June 11, 2019
File No. 25211374.50

Subject: DERF Change Order No. 7 (Revised)
Laundry Land Cleaners (former), Northgate Shopping Center
1131 N. Sherman Avenue, Madison, Wisconsin
WDNR BRRTS #02-13-552183

1.0 CHANGE ORDER SCOPE AND COST ESTIMATE

- 1 Site Map with Proposed Sample Locations

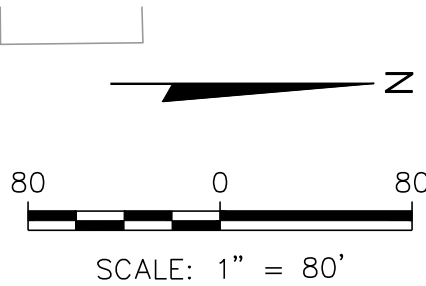
Based on the PFE test results and potential for changes in sub-slab concentrations, SCS is proposing additional vapor sampling to evaluate the current degree and extent of sub-slab vapor concentrations. Proposed approximate sub-slab sample locations are shown on **Figure 1**.

- Advance 10 direct push borings to 12 feet bgs. Proposed sample locations are shown on **Figure 1**. Final boring locations and depths will be determined based on access limitations and conditions observed in the field.
